SUBJECT: Triangle Expressway Southeast Extension (Complete 540) from NC 55 Bypass in Apex to US 64/264 (I-87) in Knightdale, Wake and Johnston Counties; Federal Aid No. STP-0540(19), STP-0540(20), and STP-0540(21); WBS Nos. 37673.1.TA1, 35516.1.TA1, and 35517.1.TA1; STIP Project Nos. R-2721, R-2828, and R-2829

From: [Williams, Andrew E CIV USARMY CESAW \(USA\)](#)
To: [Riffey, Deanna](#)
Cc: [Alsmeyer, Eric C CIV USARMY CESAW \(USA\)](#); [Matthews, Monte K CIV USARMY CESAW \(USA\)](#); [Williams, Andrew E CIV USARMY CESAW \(USA\)](#)
Subject: [External] SAW-2009-02240 R-2721A Individual Permit Modification--MOD9
Date: Tuesday, September 13, 2022 10:39:18 AM
Attachments: [R-2721A Permit Drawings 06292022.pdf](#)

Subject: MODIFICATION of 401 Water Quality Certification Pursuant to Section 401 of the Federal Clean Water Act, NEUSE BUFFER RULES, and ISOLATED WETLANDS PERMIT Pursuant to IWGP100000 with ADDITIONAL CONDITIONS for Proposed construction of the Triangle Expressway Southeast Extension (NC 540) in Wake & Johnston Counties, Federal Aid Project No. STP-0540(19-21), State Project No. 37673.1.TA2, TIP Nos, R-2721, R-2828, & R-2829.
NCDWR Project No. 20181249 version 10

PERMIT

PERMIT DRAWING
SHEET 76 OF 119

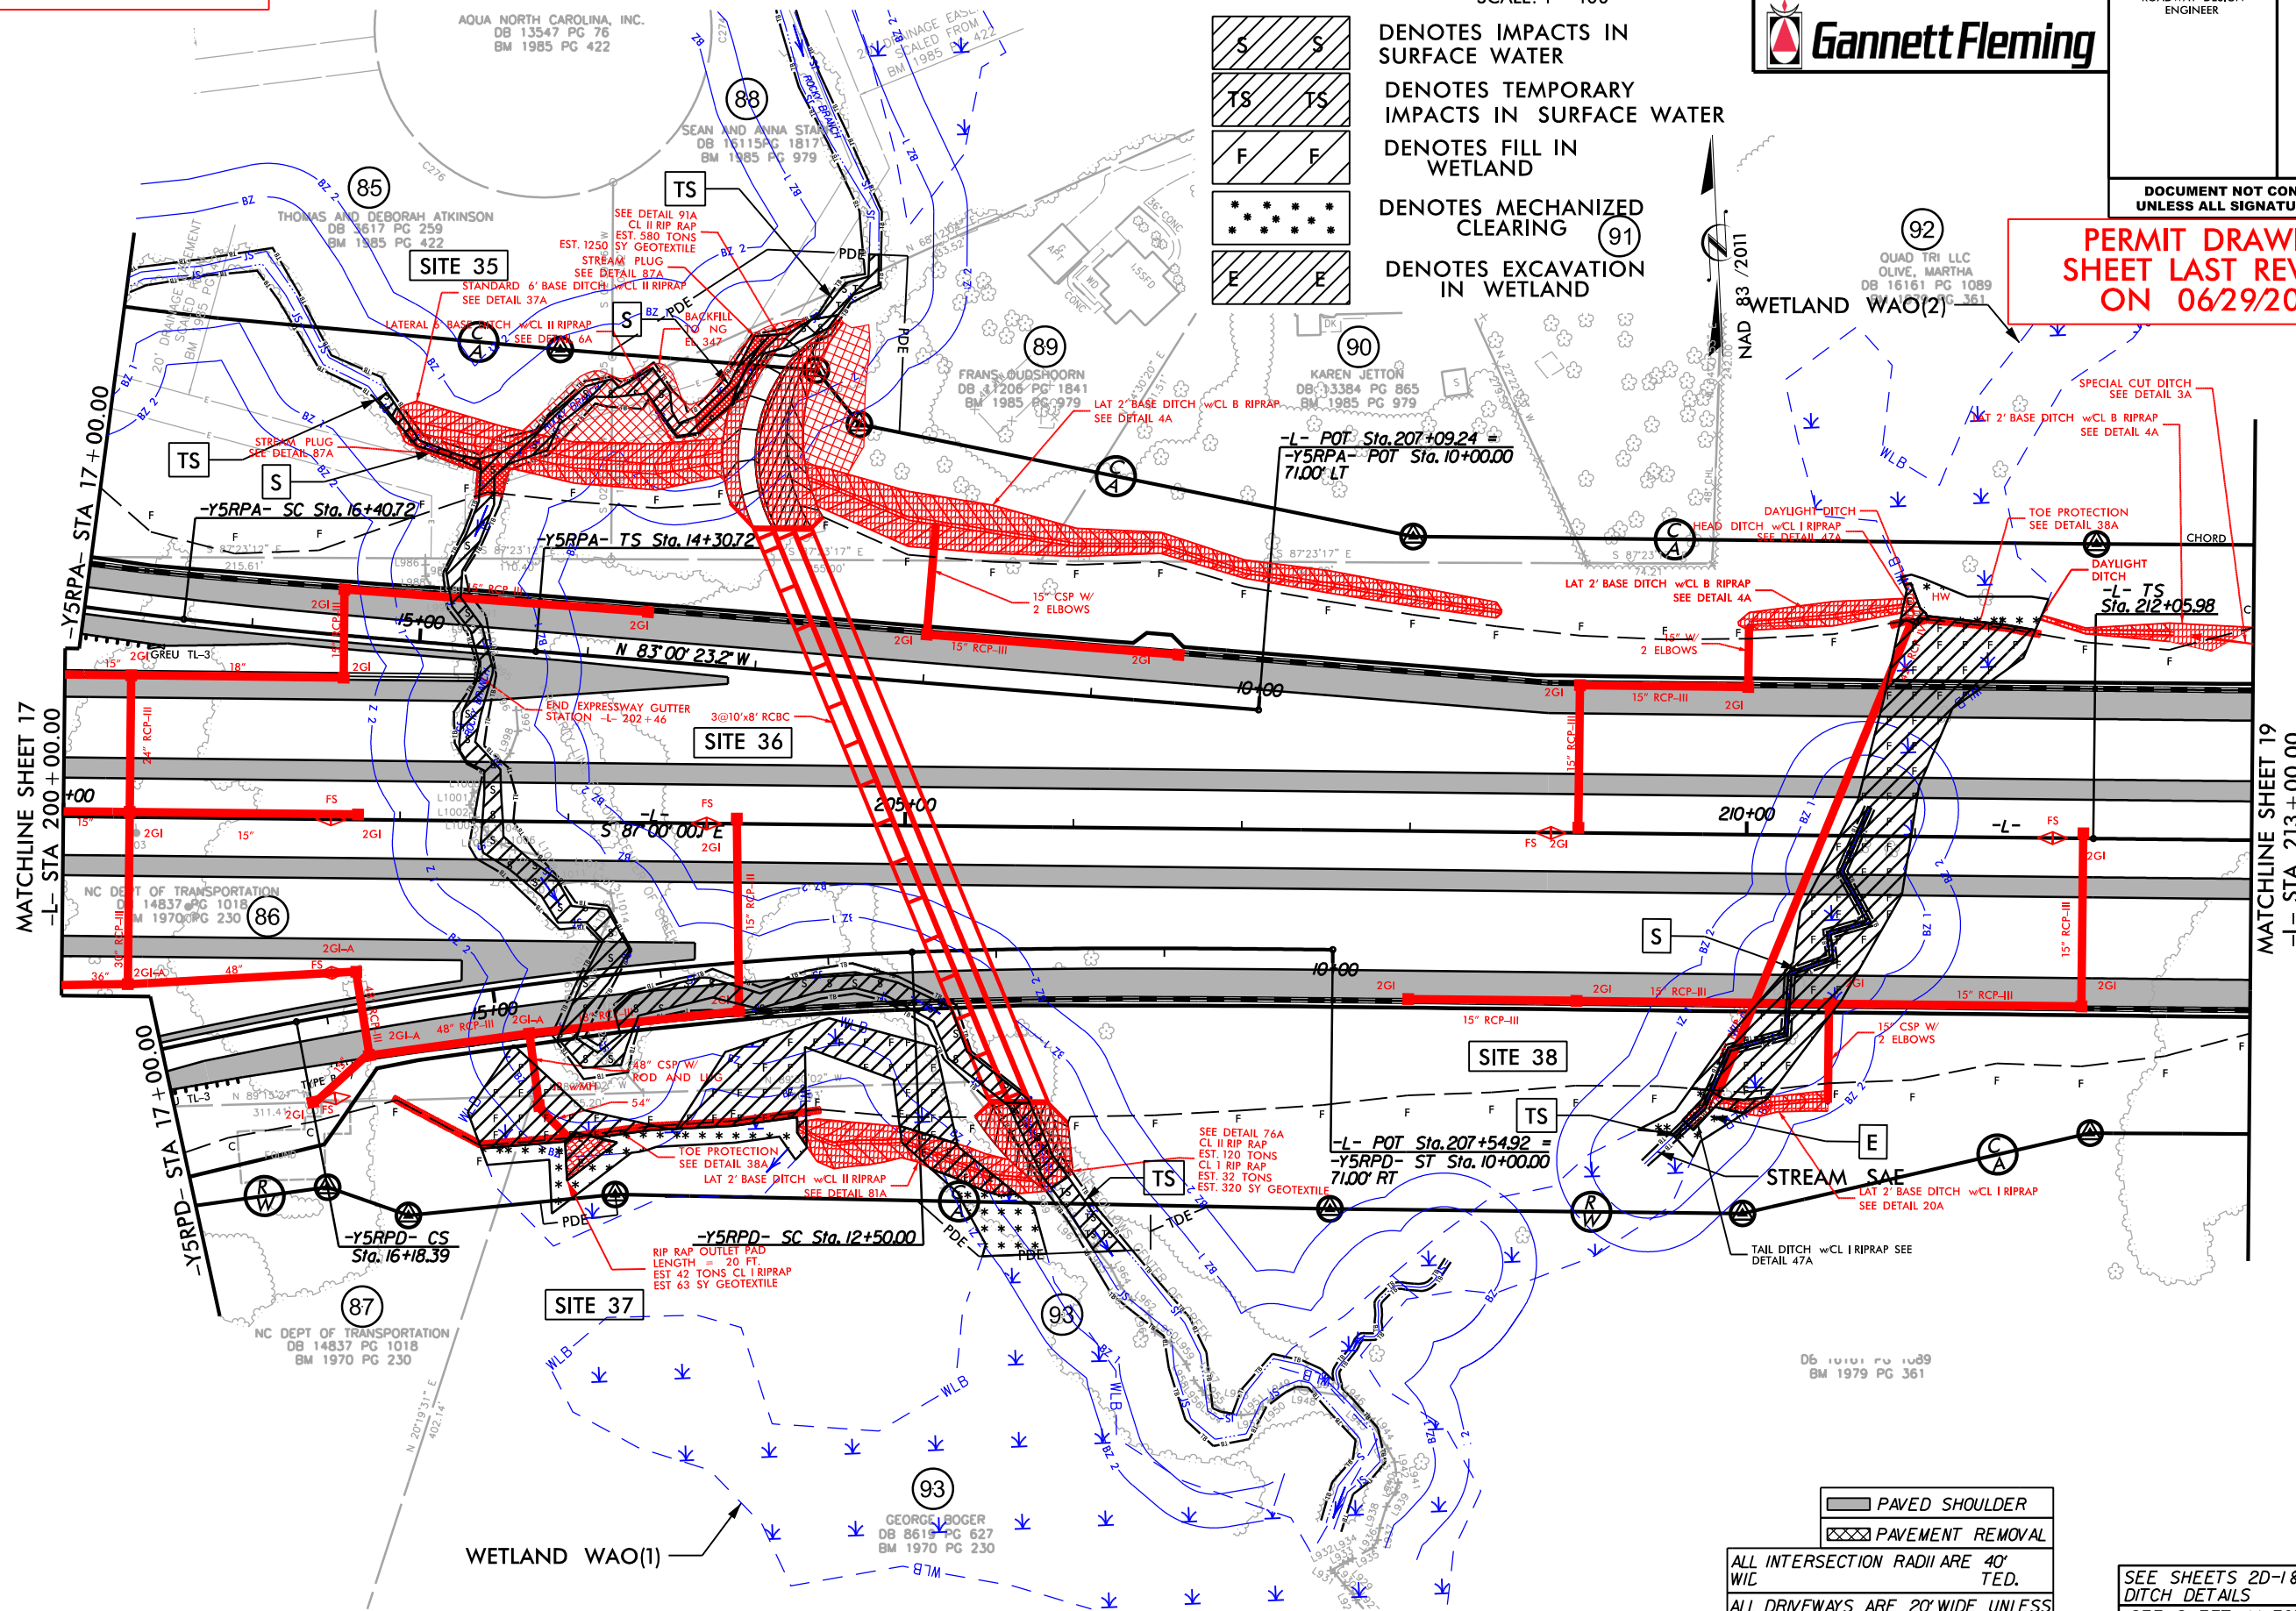
Site 38- 0.01 acre that were previously permitted as mechanized clearing would be permanently filled.

Site 38: 0.01 acres Mechanized Clearing changed to Permanent Fill.

Revised Site 6 Total Impacts: 0.31 ac Permanent Fill. 0.01 ac Excavation. 0.05 ac Mechanized Clearing.
